Re: Waste Rock Site – Subsurface Density Tests Amendment, Task ID#5343, Canyon Fuel Company, LLC, Sufco Mine

Re: Waste Sock Site Compaction Specification Amendment – Task ID#5344, Canyon Fuel Company, LLC, Sufco Mine

Permittee: Canyon Fuel Company, LLC
Mine: Sufco Mine **Permit Number:** C/041/002
Title: Waste Rock Disposal Site - Subsurface Density Tests Amendment, Task ID#5343

WASTE ROCK PILE
OPERATIONAL PLAN – PHASE 1 & 2

PEN TBL:	SCALE:	DATE:	DRAWN BY:	ENGINEER:	CHECKED BY:	SHEET NO.
_1Stndrd–HPT1100.ctb	1" = 100'	11/2/2016	JA	LF / TH	VM	MAP 2B

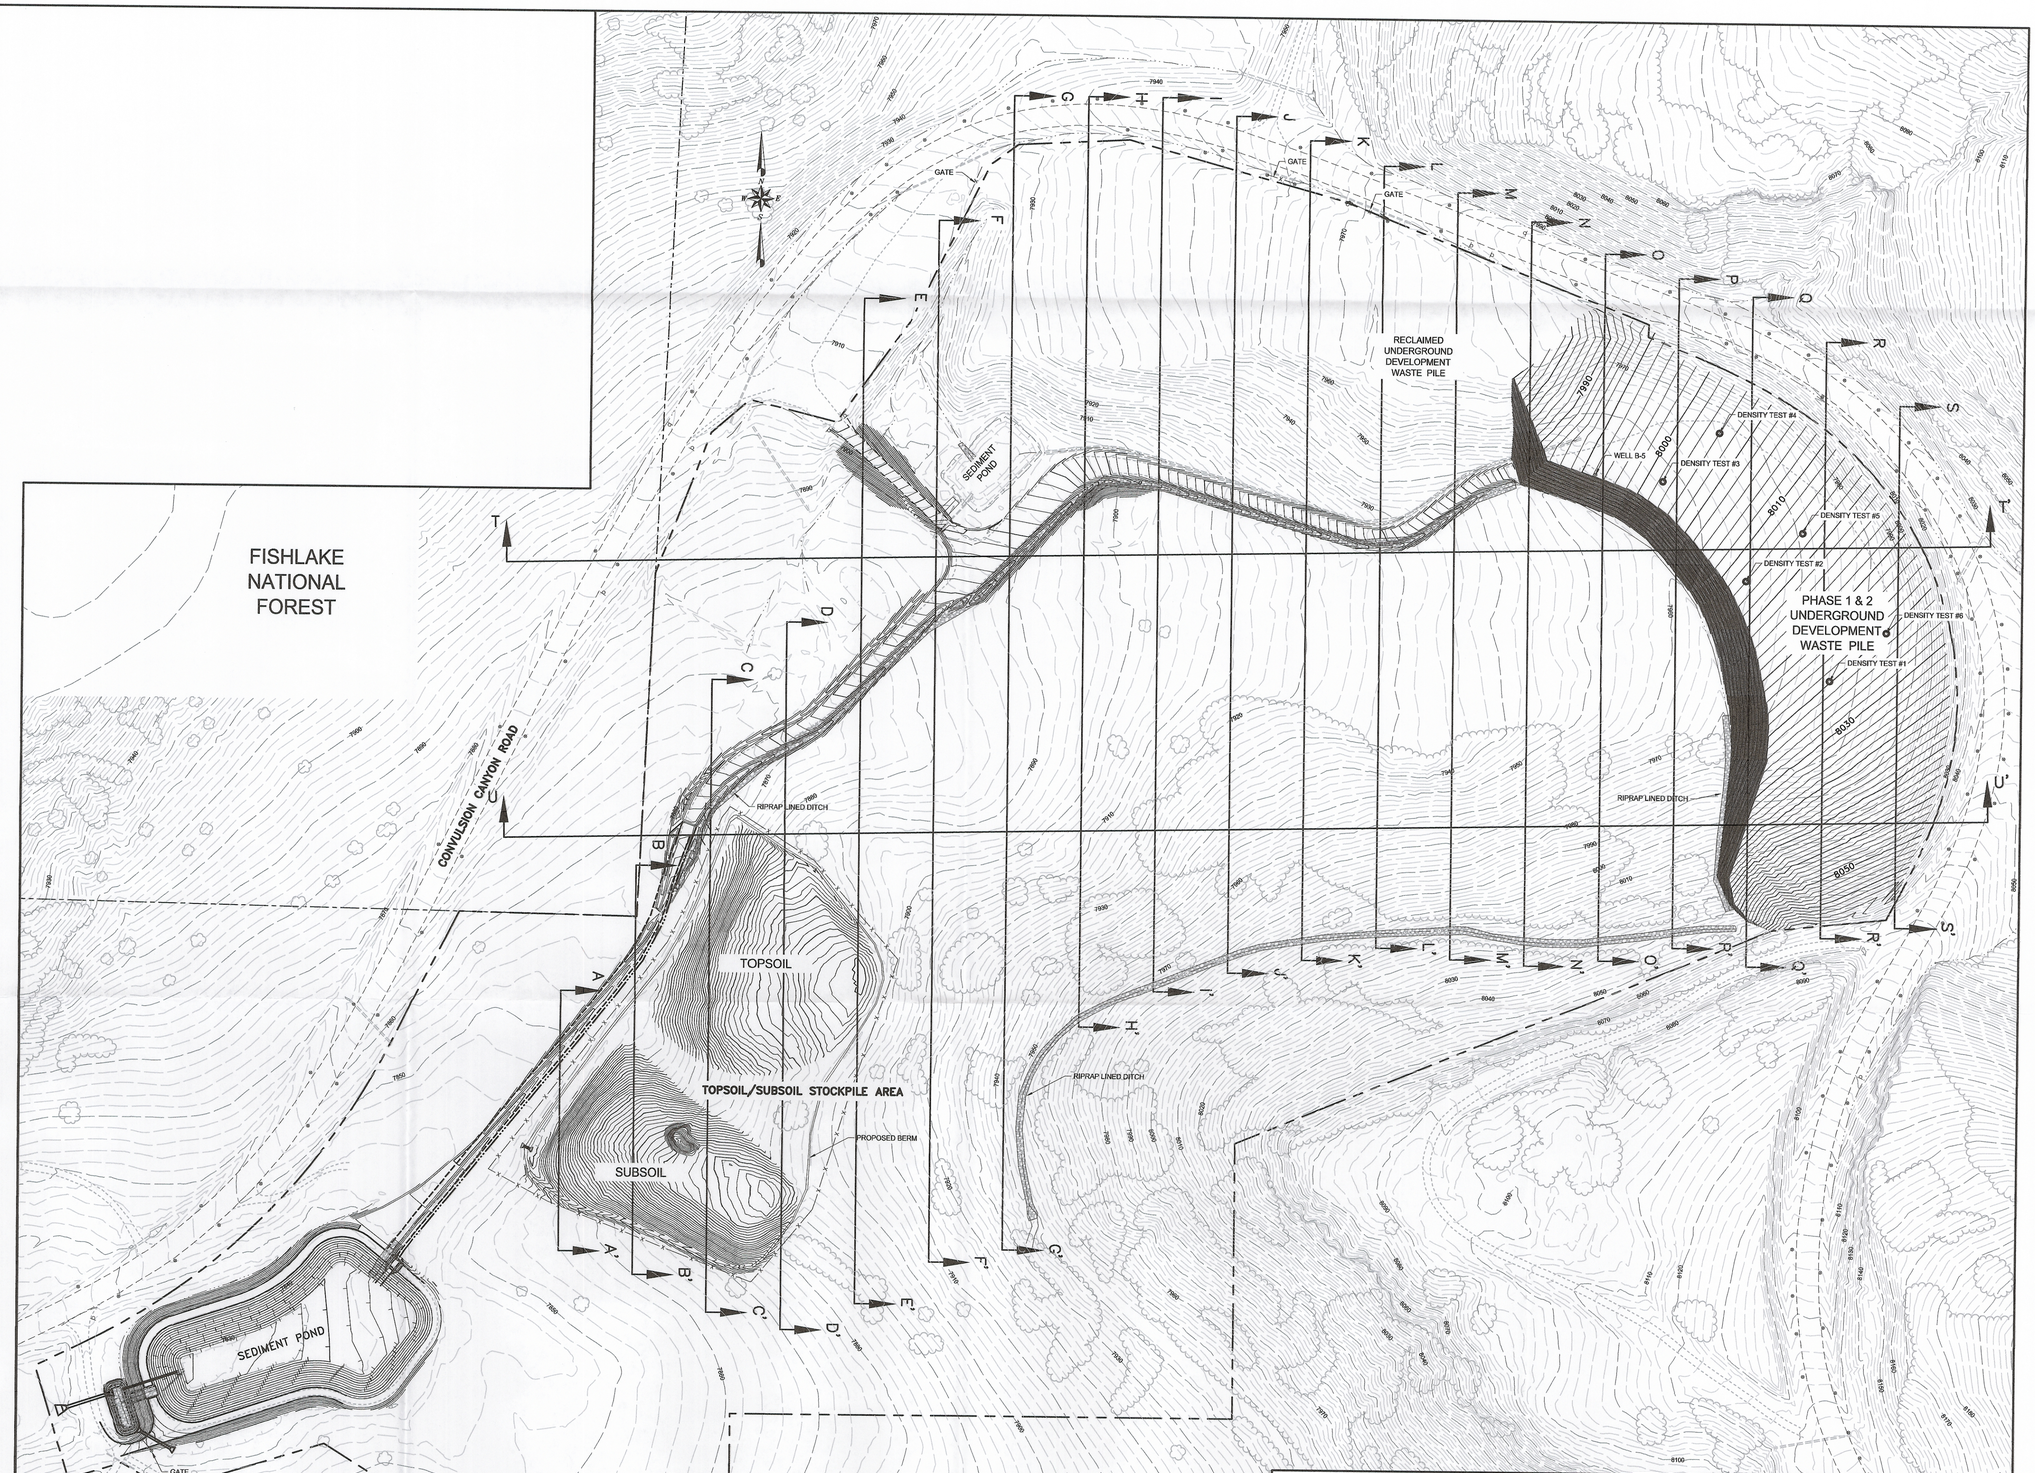
Please find enclosed with this letter clean copies of an amendment to the Sufco Mine Permit to include the density testing for the subsurface base upon which the waste will be placed. Map 2B shows the location of where the samples were taken. Appendix VIII has been added, which includes the density test results, in addition Appendix VIII has been added to the Table of Contents.

Once the topsoil and subsoil has been removed (Sections 222 and 231), subgrade surface will be scarified and re-compacted to a minimum of 90% maximum density. Subgrade surface density test data is located in Appendix VIII, the physical location of the test is shown on Map 2B. The surface density met the minimum re-compacted density limit. Densities will be taken on subgrade at a minimum of one per 5000 square yards using a nuclear density gauge. Scarification will be done using earth moving equipment such as a grader, dozer or excavator. Compaction will be done utilizing the same type of equipment by wheel rolling the subgrade surface prior to any waste rock being placed. Water will be added to material as needed to obtain compaction.
